INSPECTION OF CHAMPION DEFENDER BUS:

Re: Champion Defender bus accident, Davis, Oklahoma

The following is my specific rebuttal for Ms. Ewing's report:

Figure (3) Tearing in the Heat Affected Zone

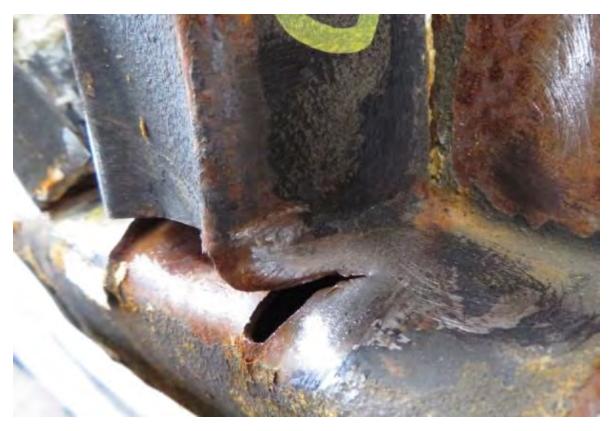
Ms. Ewing also stated that "the collision was so severe and violent that there was even base metal tearing in the tube itself." Ms. Ewing's conclusion is misleading because it omits the fact that the majority of tubular tearing occurred in the Heat Affected Zone (HAZ) of the base metal, and the weld interface. Common fatigue spots when welding processes are not proofed, documented and controlled. See Figure (3). AWS requires that all welding be controlled by a WPS (Welding Procedure Specification), which will control the amount of Joules heat input ingested into the base metal, changing the molecular structure, and resulting in a change in the mechanical properties of the parent metal. Manufacturers are required to proof their processes and demonstrate weld soundness by methods of destructive and non-destructive examination to ensure sound weld quality. Ms. Ewing mentioned visual inspection and macro-etch testing – these are two ways to test the soundness of a weld and should be applied prior to fabrication. No such test results have been furnished.

Figure (1)

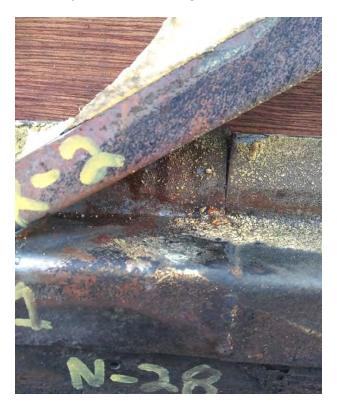
Passenger Side: Section L2(P) Item D & E, Z sidewall 16GA x 96.00 and Z sidewall 16GA x 74.00 vertical section of joint not welded (Figure 1)
